AURIX™ TC36x errata sheet

Marking/Step: (E)ES-AA, AA

10592AERRA

Figure 1 Message buffer transfer from Message RAM to OBF

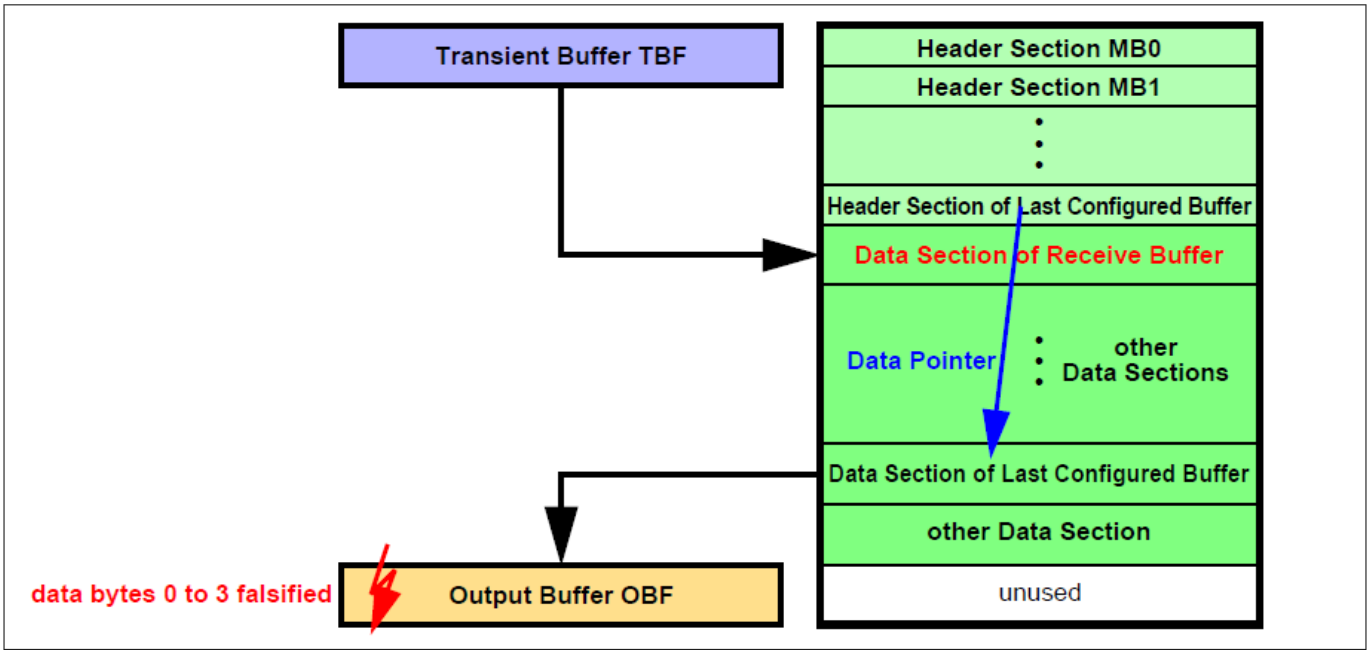
a) When a message is transferred from the Last Configured Buffer in the Message RAM to the OBF and PLC = 127 it may happen, that at the end of the transfer the OBF word on address 00h (payload data bytes 0 to 3) is overwritten with unexpected data (see Figure 1)

Figure 2 Message buffer transfer from IBF to Message RAM

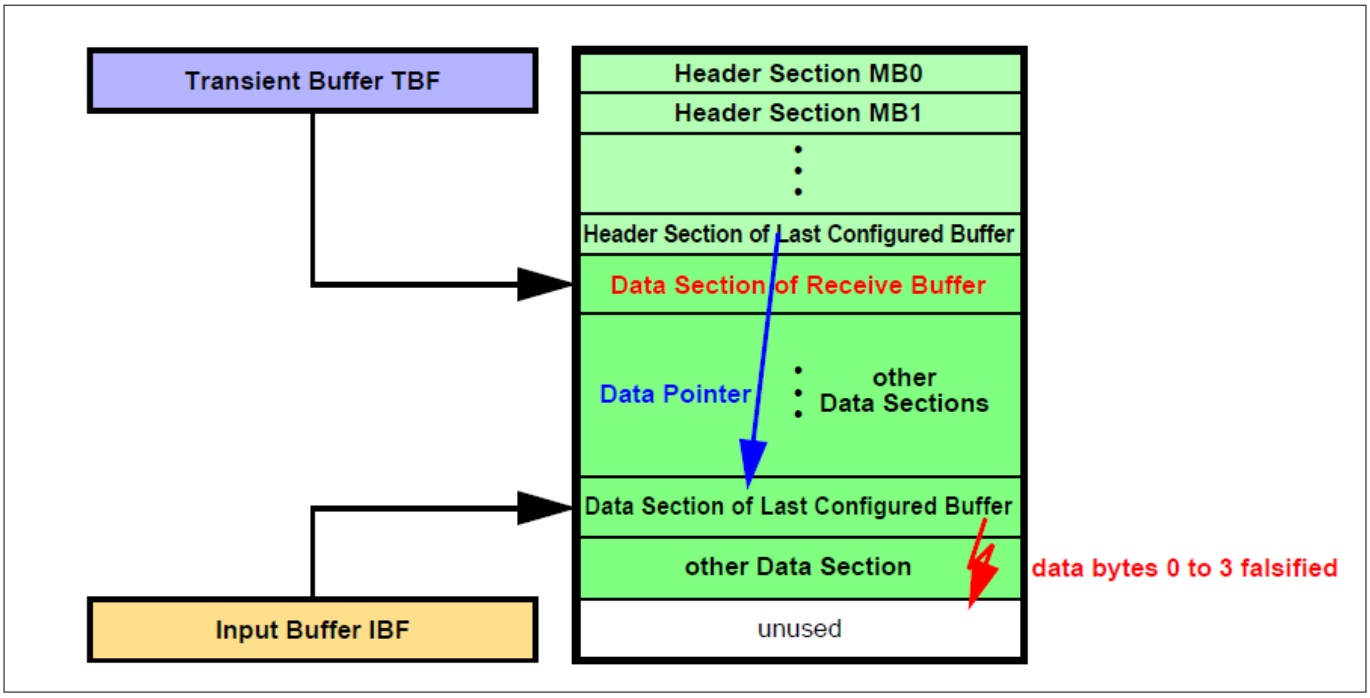
b) When a message is transferred from IBF to the Last Configured Buffer in the Message RAM, it may happen, that at the end of the transfer of the Data Section one additional write access overwrites the following word, which may be the first word of another message's Data Section in the Message RAM (see Figure 2)

Figure 3 Message RAM configurations

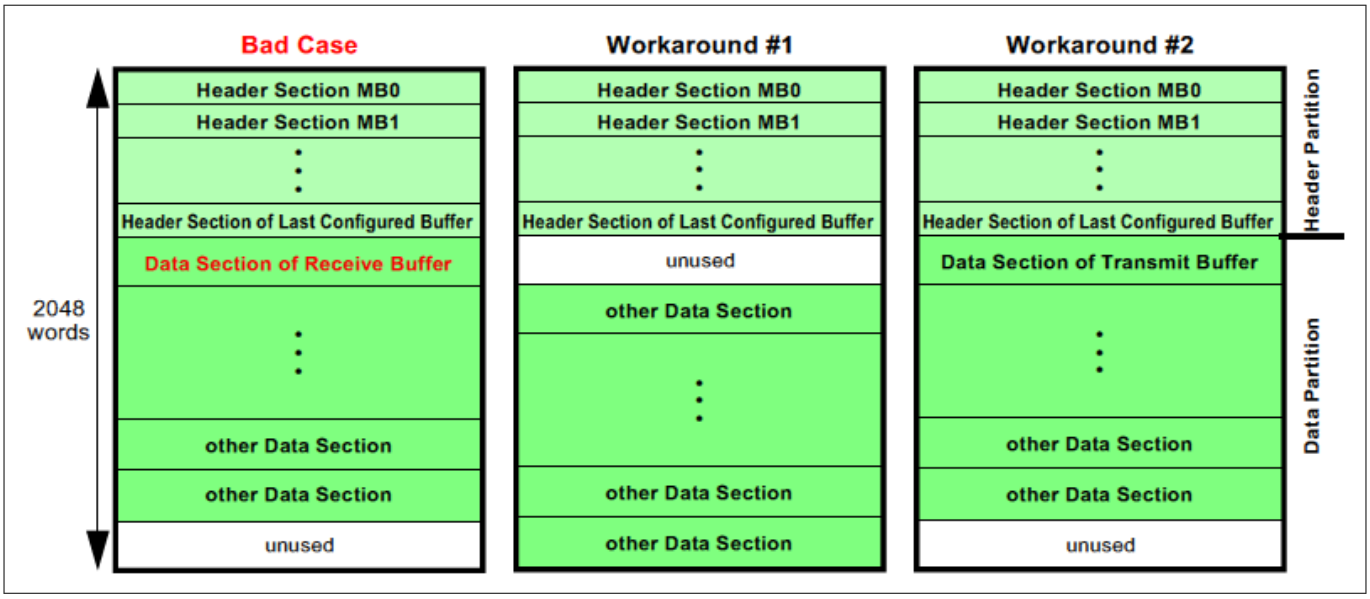
The erratum is limited to the case when (see Figure 3 “Bad Case”):

Ensure that the Data Section directly following the Header Partition is assigned to a transmit buffer.

Figure 6 Critical MCS AEI master scenario

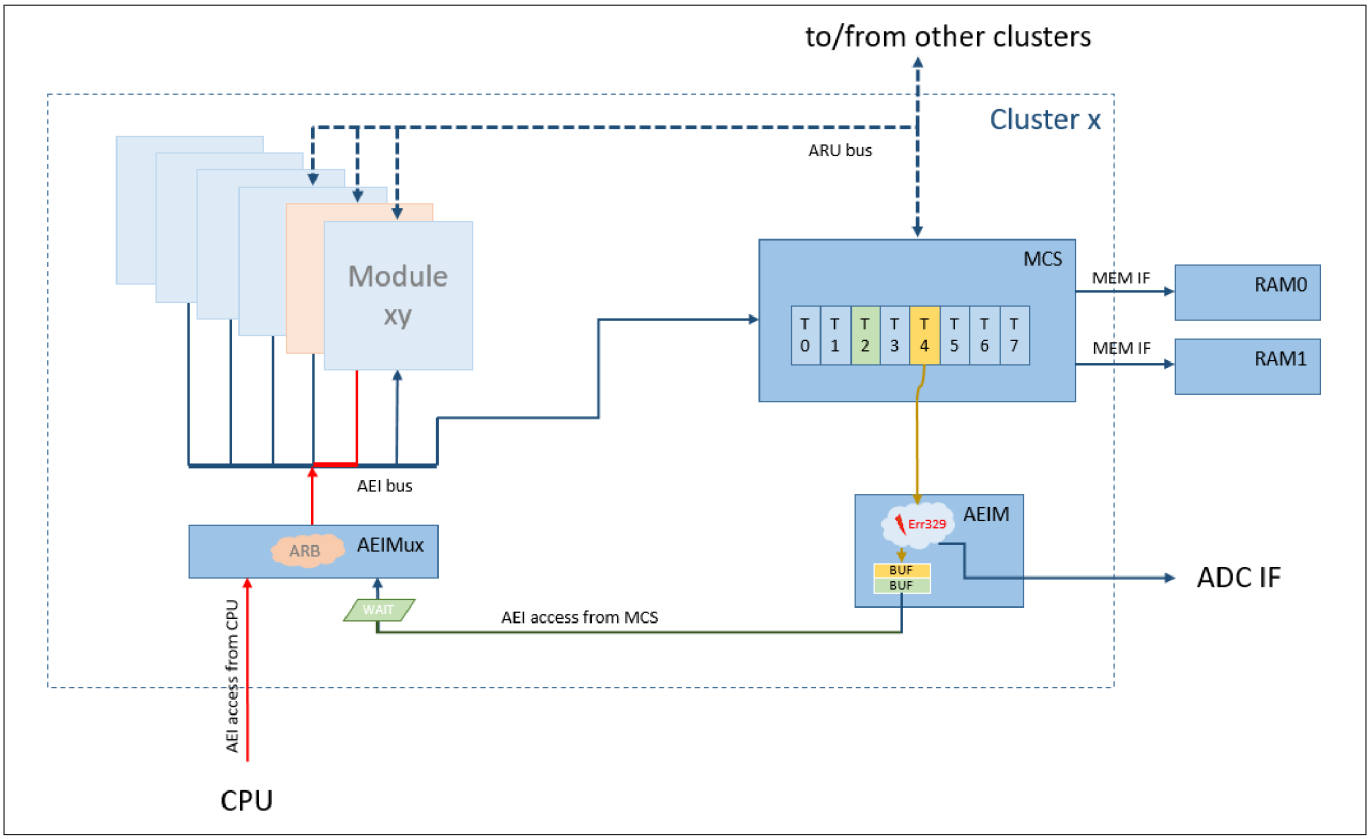
In Figure 6, a potential risk for the occurrence of problem GTM_AI.329 is illustrated. Here the first buffer of the AEIM (green) is still waiting for the access to the AEI bus while a second AEI bus access from MCS arrives at the AEIM (yellow access path). Under certain, but for the user unpredictable timing conditions, this second AEI bus access arriving at the AEIM can trigger the misbehavior described in problem GTM_AI.329.

The workarounds described in the 'Workaround' section will ensure that not more than one AEIM buffer will be filled and therefore the occurrence of problem GTM_AI.329 is avoided. All workarounds have been tested and proven correct.

Figure 7 MCS token mechanism

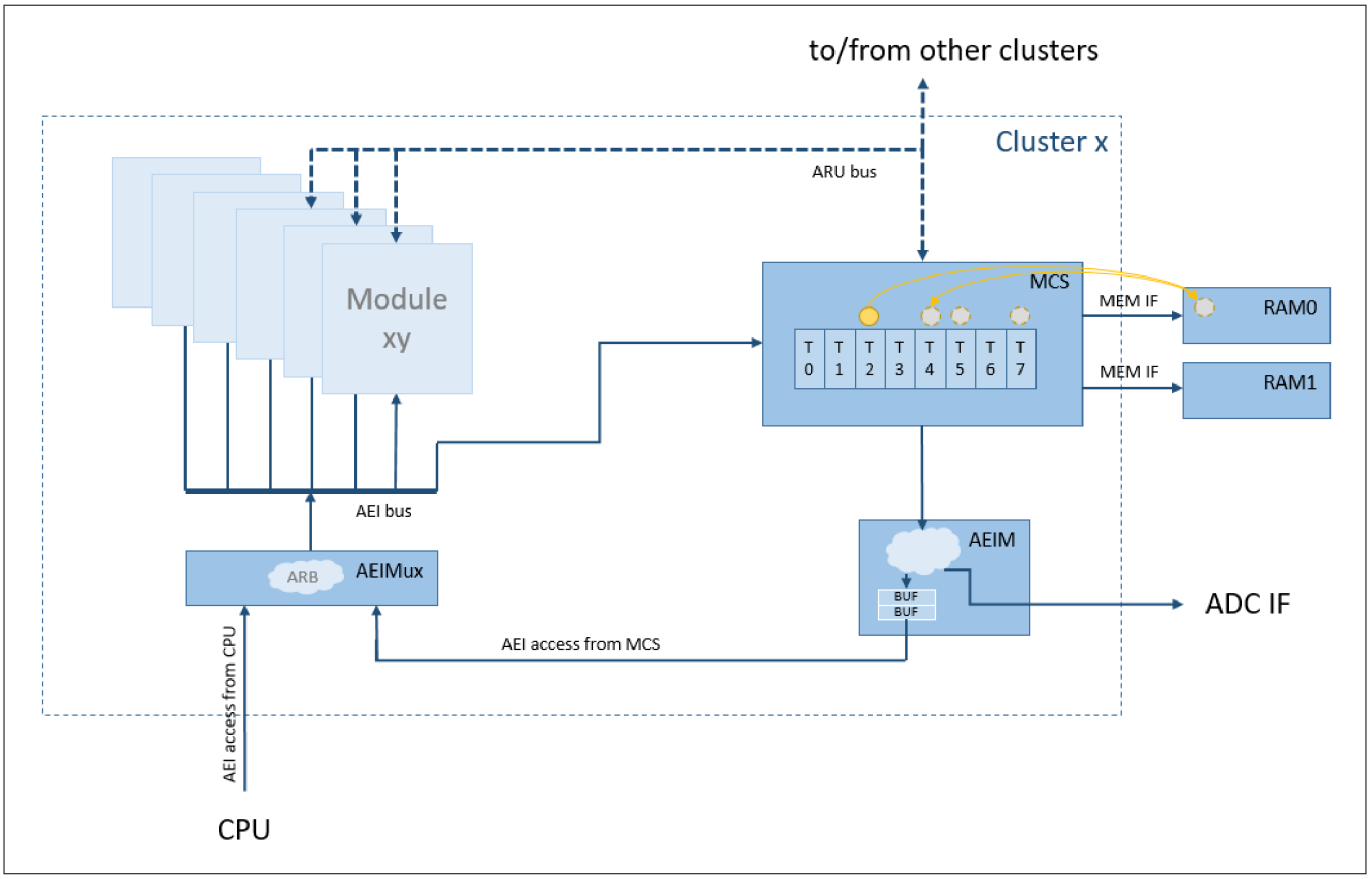
In case multiple MCS channels want to use the AEI master port for AEI or ADC communication, establish a mechanism that ensures that only one channel uses the AEI master at a time (e.g. exchange a token between channels or use trigger registers to hand over the AEI master port ownership between MCS channels).

An application note (AN020 – MCS Mutex implementation) describing a token exchange mechanism between MCS threads is available at Bosch. Such a token mechanism allows multiple MCS threads to safely access the AEI bus system by exchanging an AEI bus access token via MCS memory.

Figure 8 TBU value evaluation MCS against other modules. Red (past) and green (future).

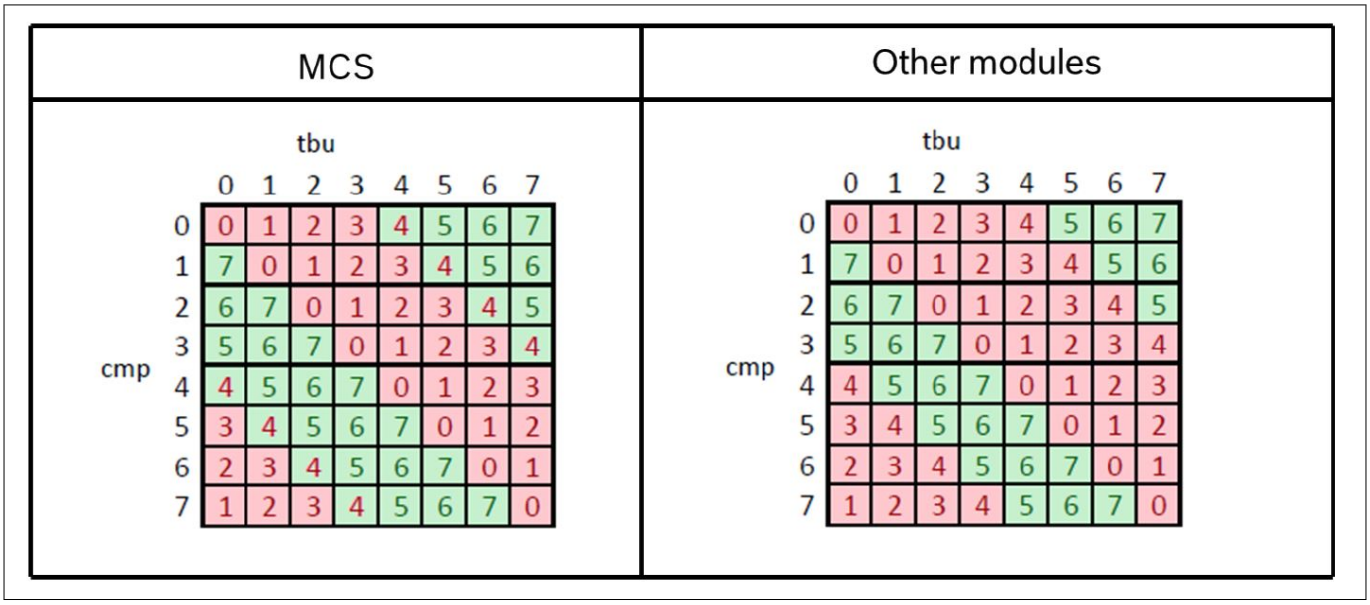
With the revised specification of GTM 4.1 it was revealed that the implementation for the WUCE instruction is not correct for the boundaries. The implementation of the WUCE instruction has an inverted behavior for both boundaries between future and past.

Figure 10 CAN Frame with DLC > 4

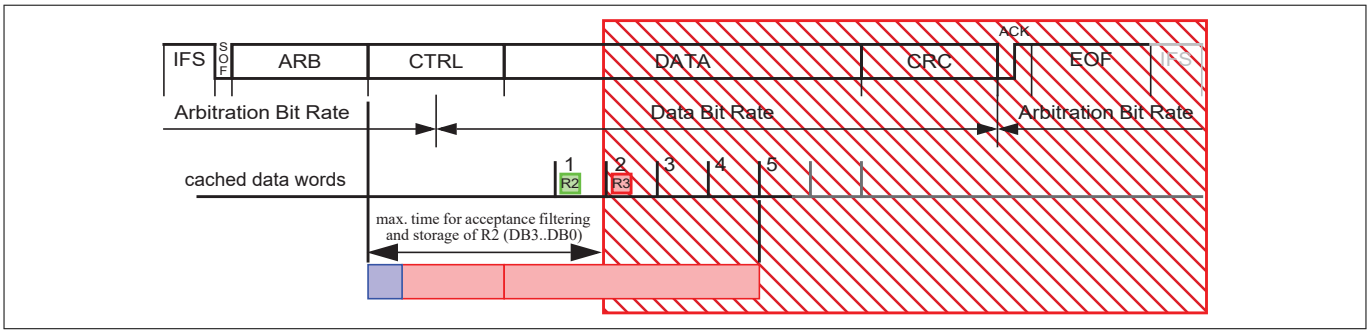
The figure that follows shows how the available time for acceptance filtering and storage is reduced.

Figure 11 Interrupt Level vs. Pulse-Notify mode - Corner Case Example

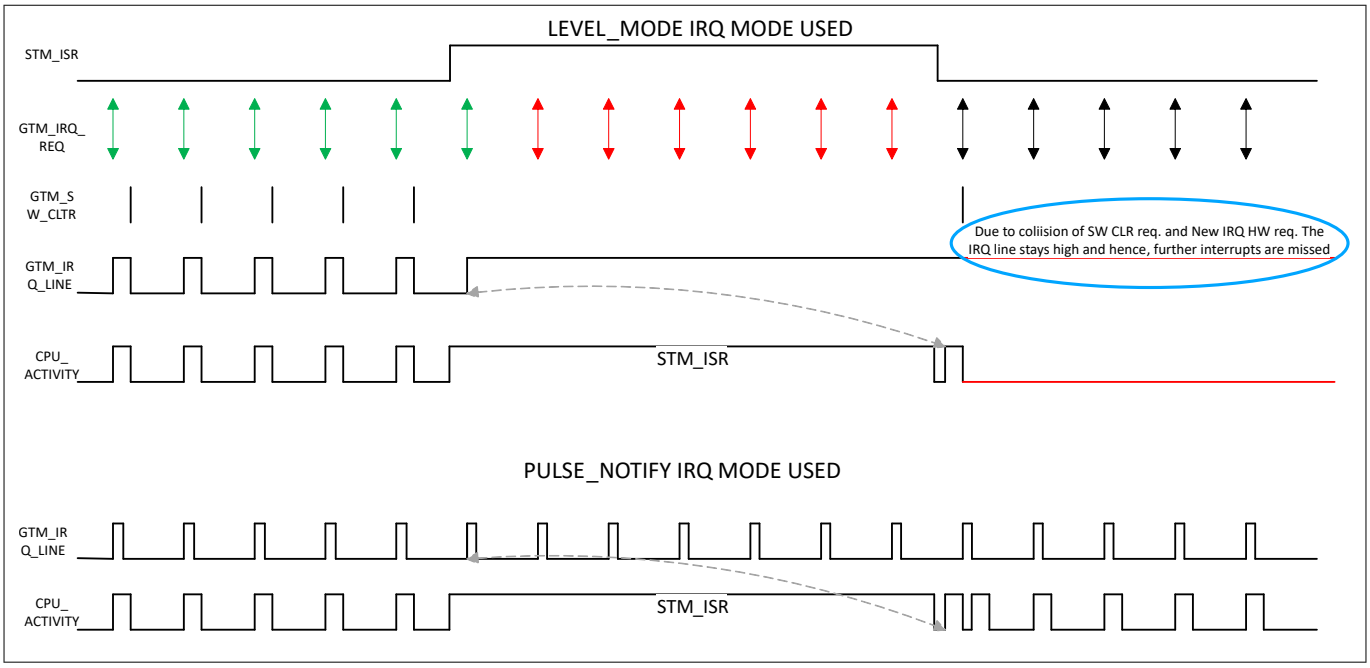
interrupt and clear events), GTM_IRQ_XXX is not cleared and remains high. As a consequence, the IR observes no transition on GTM_IRQ_XX. Thus, any forthcoming interrupt events in this scenario are lost as there is no chance to release the CPU IRQ when a collision happens as shown in Figure below.

If Pulse-Notify mode is selected, every internal trigger will be forwarded to the IR, irrespective of the time of occurrence and the clear event, as the pulse-notify leads to set and reset of GTM_IRQ_XXX as compared to only setting of the GTM_IRQ_XXX line in Level mode.

Figure 12 Timing of LVDS TX interface command sending in relation to IRQ.IFCFS

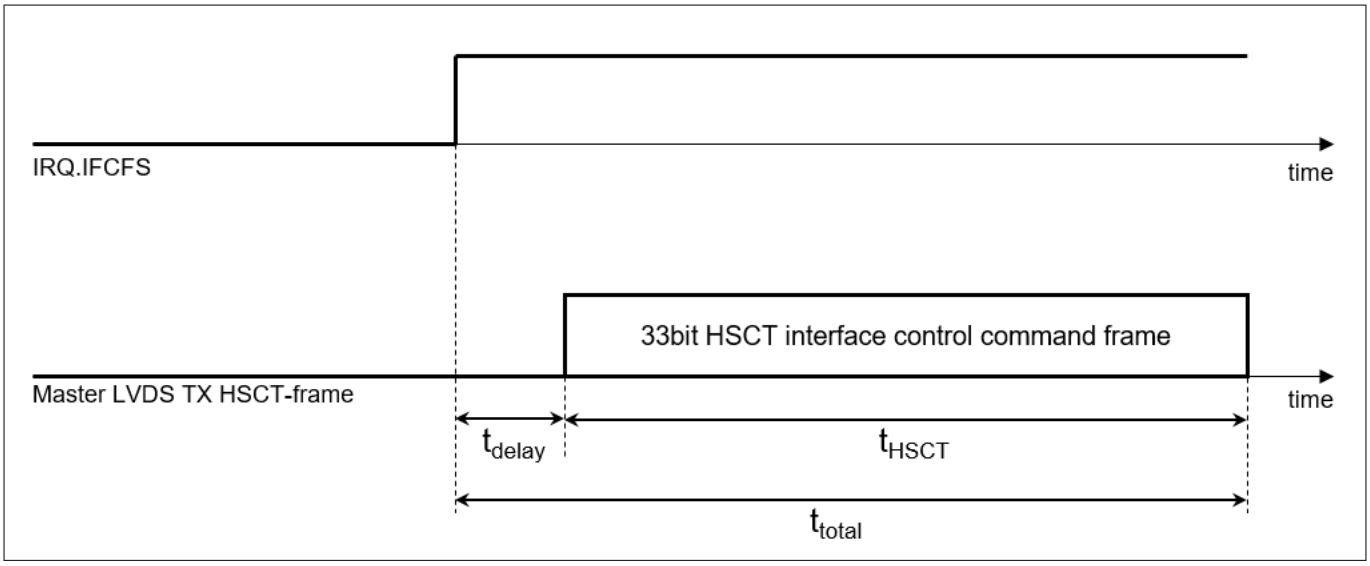
the user might falsely assume that also the actual sending on the LVDS TX port has already occurred once the IRQ.IFCFS flag is set, which is not true.

Instead the timing shown in the following figure applies.

Figure 13 Package Outlines LQFP-176 for TC36x

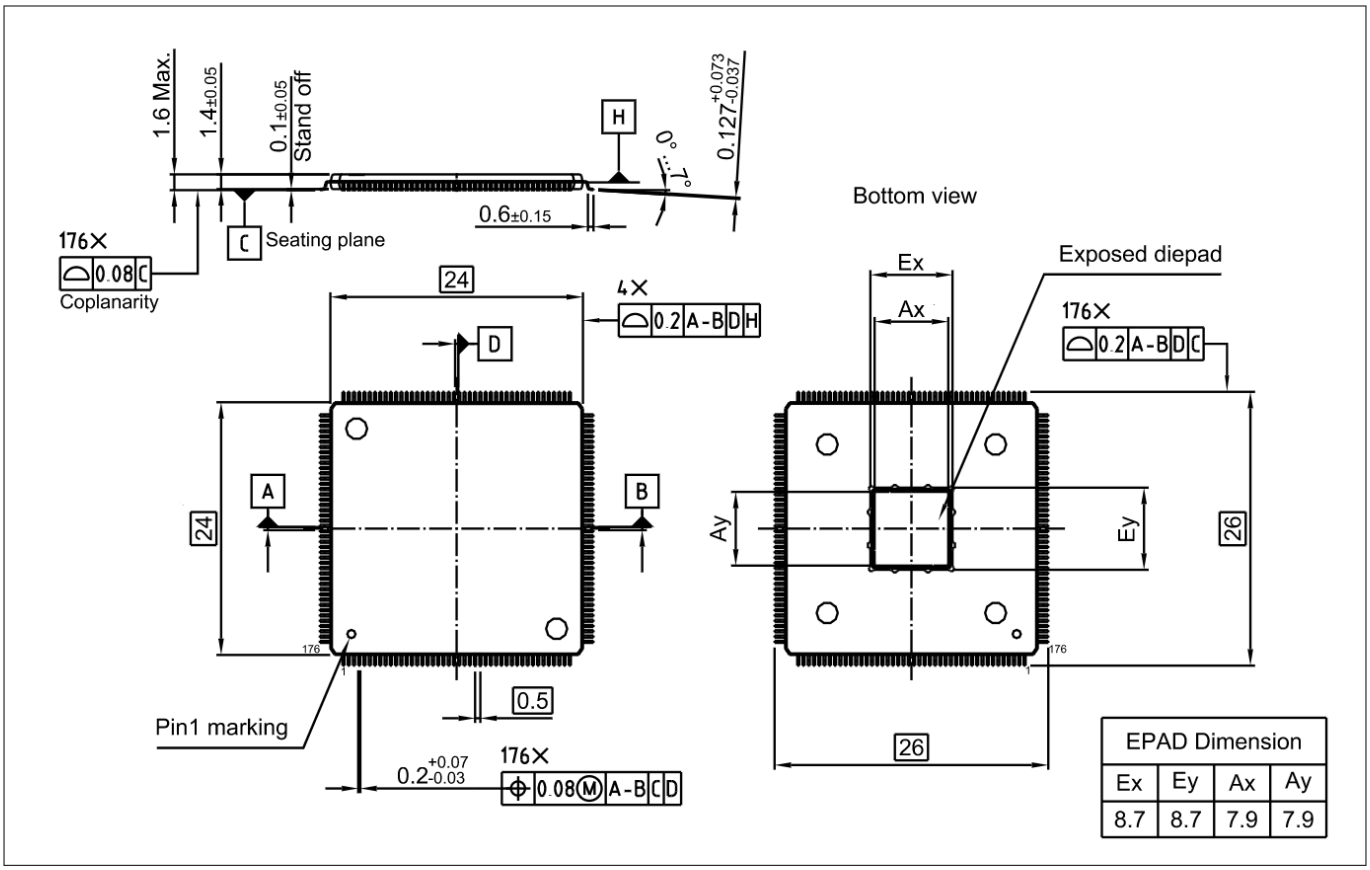
The dimensions for the exposed diepads have been corrected and included into the respective figures. This replaces the corresponding information in erratum text module PADS_TC.P013 (Exposed pad dimensions for QFP packages - Correction to TC36x Data Sheet V1.1).

This information shall substitute the corresponding information in the TC36x AA-step Data Sheet V1.1.

***Note**: For the exposed diepad of the LQFP-176 package of the TC36x, structural corner protrusions have to be considered for purposes of system design and integration with a maximum boundary of 9.4 mm.*
